Planning Officer's Report - LDCA MARCH 2023

APPLICATION	2023/04 – Proposed Balcony & Verandah Extension
PERMISSION SOUGHT	Full Permission
REGISTERED	26 th January 2023
APPLICANT	Marjorie Harding
PARCEL	JT130025
LOCALITY	Sapper House, Upper Jamestown
ZONE	Intermediate Zone
CONSERVATION AREA	Jamestown Historic Conservation Area
CURRENT USE	Existing House
PUBLICITY	The application was advertised as follows: <ul style="list-style-type: none">▪ Sentinel Newspaper on 26th January 2023▪ A site notice displayed in accordance with Regulations.
EXPIRY	9 th February 2023
REPRESENTATIONS	One Received
DECISION ROUTE	Delegated / LDCA / EXCO

Diagram 4: Revised Layout & Elevation

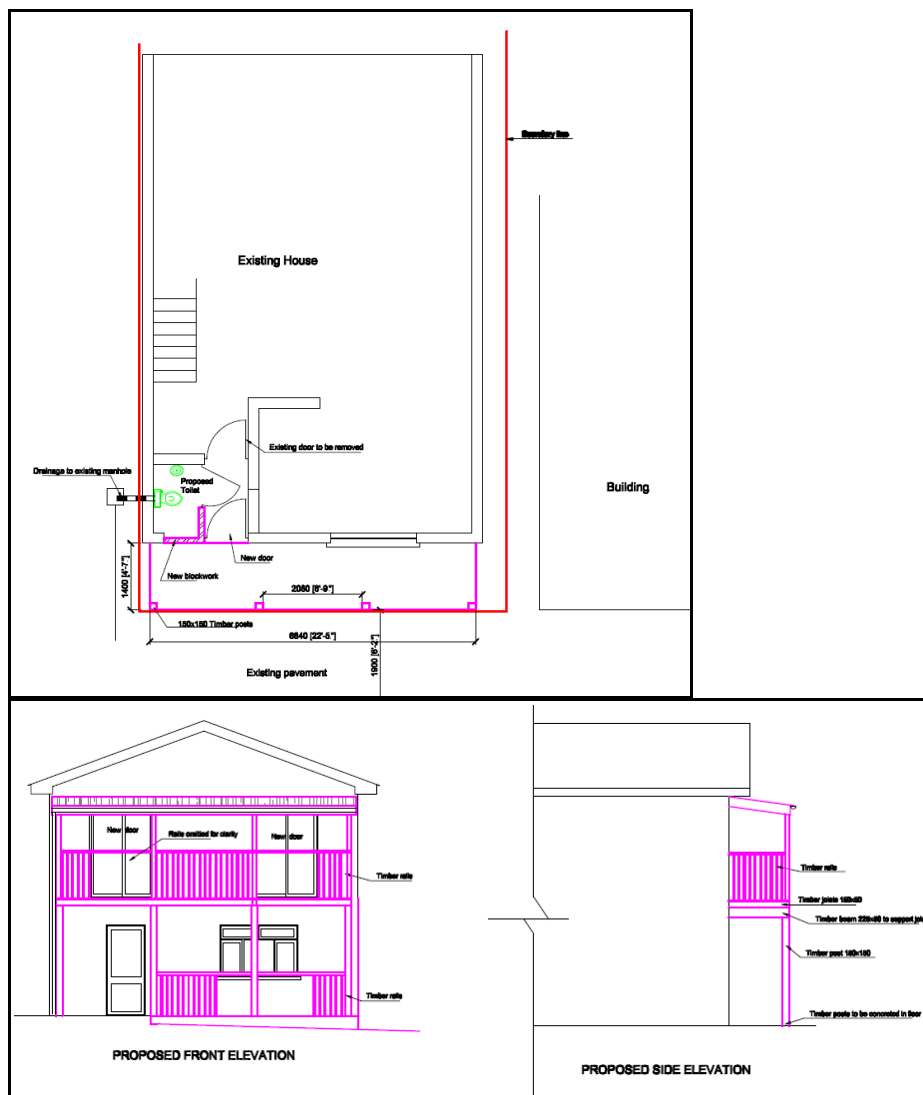
St Helena National Trust: Objection – ‘The St Helena National Trust is trying to ensure that the front facing buildings of Jamestown retains its Georgian heritage. Whilst this building is somewhat different to most of the buildings in the area and newly built (and I appreciate a few more have been changed in appearance), we are objecting as building a veranda on the front does not have the same aesthetic look and feel of Jamestown.

The proposal for a balcony is also out of character as balconies are not traditional in the street scene. Given the climate, it may not be very functional without a roof or a screen on the southern side. I would suggest the applicant be encouraged to modify the application to include both of those.

To this end I would also suggest setting the veranda in from the edges of the house about 6ins; add a shallow hipped roof to sit under the gable, which would also help rain water drainage; and at the street front build a 3'6" high rendered boundary wall on which to sit the veranda instead of the proposed fence.

Having carried out a site visit to the property, as well as assessing the proposal, consultation and public representations, the balcony and verandah as proposed in its design could be amended to be more sympathetic with the character of the conservation area, therefore the applicant was asked to consider a re-design, where they have now added a lean-to roof to the first floor balcony creating an open verandah, as well as re-positioned the verandah from the edge by approximately 150mm either side.

National Trust mentions that the verandah does not have the same 'aesthetical look and feel' of Jamestown. The building itself is out of character due to its appearance as well as being set back from the building line of neighbouring properties. The proposed extension will align with the neighbouring properties and not protrude onto the walkway. The roof over the balcony to form a verandah now gives a much more traditional feel and appearance compared to the initial proposal, where it will enhance and protect the character of the area. Overall, the proposed development will not adversely impact the setting of the conservation nor amenity of existing development, and therefore can be supported.
